AUD-MERO-17-44

Management Assistance Report: Building Deficiencies Identified at U.S. Embassy Kabul, Afghanistan Need Prompt Attention

Figure 3: Properly Installed "P" Trap versus Prohibited "S" Trap

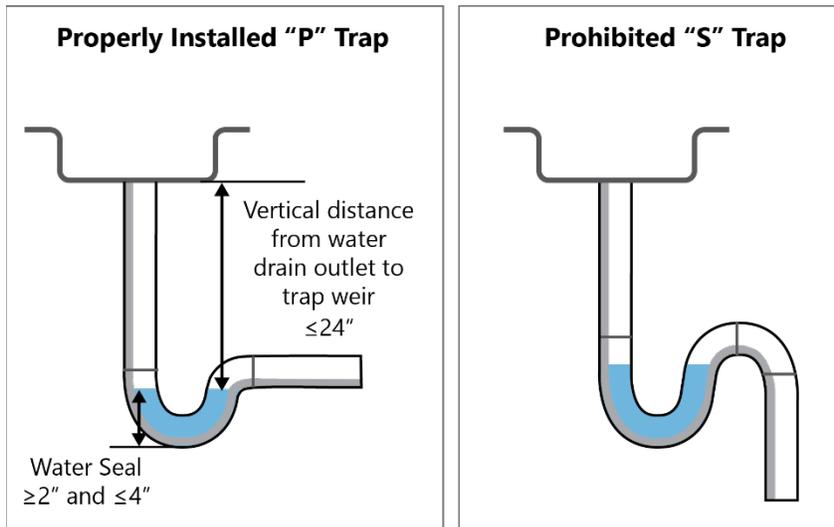
After completing an assessment of plumbing systems, PAE reported that incorrect water-seal traps had been installed beneath fixtures in SDA-1. Specifically, they found that the contractor had installed "S" traps, rather than the more appropriate "P" traps throughout the building. USACE engineers reviewed the assessment completed by PAE and concurred that there were issues with the design and/or installation of plumbing systems. The purpose of a trap is to prevent sewer gases, and possibly vermin, from coming into the building; more specifically, when water sits in the trap, sewer gases stay out. The S traps that were used in SDA-1 do not accomplish this goal. In fact, the International Plumbing Code (Chapter 10, Section 1002.3) prohibits the use of "S" traps because they are not properly vented and have the potential to siphon water out of the trap as water flows down the drain. If enough water is siphoned out of an "S" trap, it can break the water seal and allow sewer gases to come into the residence. In contrast, on a properly installed "P" trap, there is a vent at the same place the drain turns downwards, which breaks the siphon. The vent prevents water from getting sucked out of the trap. Figure 3 compares these two types of traps.

Recommendation 1: OIG recommends that the Bureau of Overseas Buildings Operations have a qualified professional experienced in the installation of plumbing systems conduct a full inspection, analysis, and recommissioning of waste and vent plumbing systems in the Staff Diplomatic Apartment-1. This inspection should include a comprehensive review of all submittals, plans, and specifications, as well as all installation methods and materials.

OBO Response: OBO concurred with the recommendation, stating that it had informed Caddell that “any construction not in compliance with the contract must be mitigated at its expense.” According to OBO, a senior mechanical engineer from OBO in Washington

Figure 11: Boiler in 7th floor mechanical room of the NOX.
Source: Photo taken by USACE on February 15, 2016, and verified by OIG on April 9, 2017.

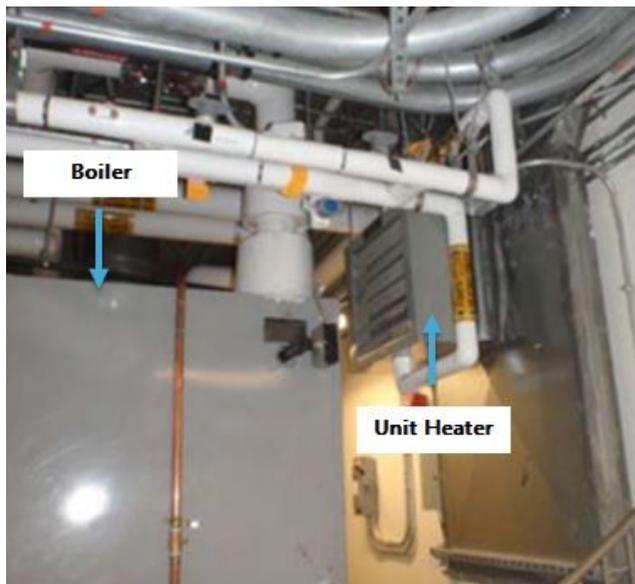
Insufficient Clearance around Boiler in the 7th Floor Mechanical Room of the NOX

The hot water unit heater in the mechanical room on the 7th floor of the NOX is installed too close to boiler box 7-2. Contract drawings show the boiler should have adequate clearance on all sides to allow for routine maintenance. However, as shown in Figure 11, access to the boiler is obstructed by the placement of the unit heater.

Recommendation 10: OIG recommends that the Bureau of Overseas Buildings Operations implement actions to correct all heating, ventilation, and air conditioning system installations in the New Office Annex and Staff Diplomatic Apartment-1 that do not conform to the contract requirements, including the specific examples OIG cited in this report.

OBO Response: OBO concurred with the recommendation, stating that it "has informed Caddell that any installations not in compliance with the contract must be mitigated at its expense." OBO also commented on several of the examples cited in this report. First, while OBO concurred that the placement of the chilled water supply line on the rooftop of the NOX is "not optimal," it stated that relocating the chilled water line would require shutting down the system and would be disruptive. "The current placement meets code and manufacturer's requirements for minimum clearances." Second, OBO stated that it had verified that the heater was not obstructing the boiler's access panel on the seventh floor NOX mechanical room. Third, with respect to improper use of galvanized pipe fittings, "[i]f there are examples of dissimilar metals without dielectric unions, OBO will inform Caddell that any installations not in compliance with the contract must be mitigated at its expense." Finally, OBO stated that based on a recent inspection that post-dated the draft report, it had verified that no loose pipe hangers were found in either building, suggesting that the errors may have been corrected prior to the issuance of a draft of this OIG report.

Figure 15: Smoke Detectors in NOX inaccessible for testing and maintenance.

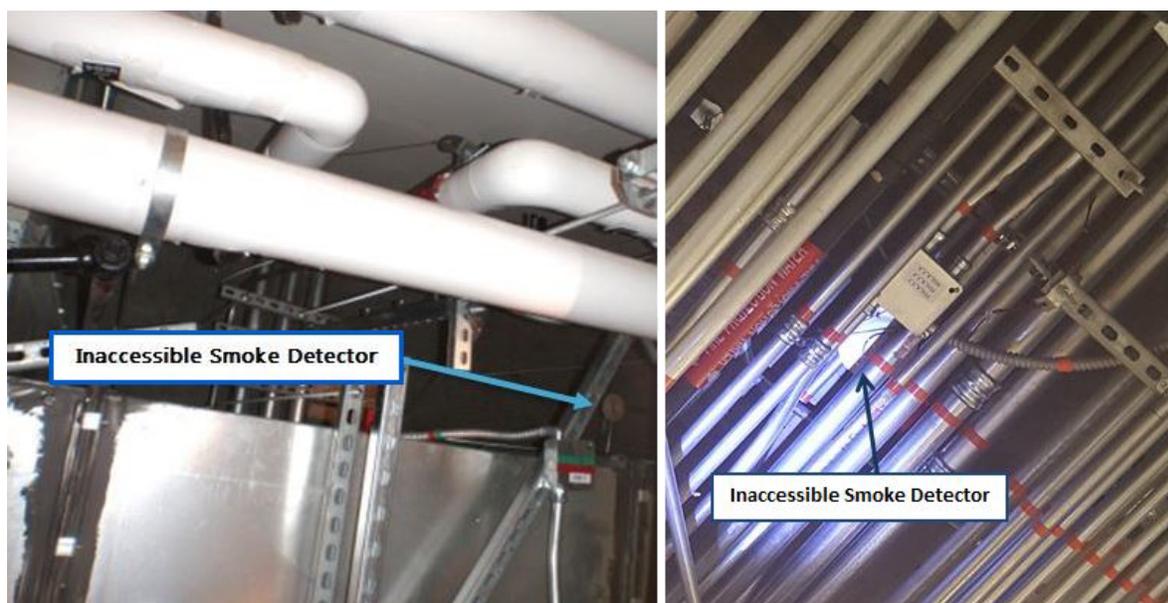
he found to be inaccessible (which were similar to the smoke detectors in Figure 15) be relocated before he would sign off on fire safety.²⁴ However, in February 2016, following substantial completion and occupancy of both the NOX and SDA-1, USACE mechanical engineers identified additional smoke detectors in the mechanical rooms of both buildings that were blocked by HVAC and electrical equipment and thus were inaccessible for maintenance. One year later, in February 2017, OIG also observed a number of smoke detectors in mechanical rooms in the NOX that had not been relocated and remained inaccessible for maintenance. PAE estimated that approximately 10 to 15 smoke detectors in the NOX do not comply with NFPA 72 because they are inaccessible for maintenance.

OBO Response: OBO concurred with the recommendation, stating that OBO personnel in Kabul relocated all smoke detectors in the NOX and SDA-1 as requested by the OBO Office of Fire Safety. OBO further stated that the contractor will relocate smoke detectors identified by contract maintenance staff as inaccessible and OBO's Office of Fire Safety will confirm that the relocations meet NFPA 72 requirements during future visits later this calendar year.

OIG Reply: On the basis of OBO's concurrence with the recommendation and actions taken and planned, OIG considers this recommendation resolved, pending further action. This recommendation will be closed when OIG receives and accepts documentation demonstrating that all inaccessible smoke detectors in the NOX and SDA-1 have been relocated and are in compliance with NFPA 72 requirements.
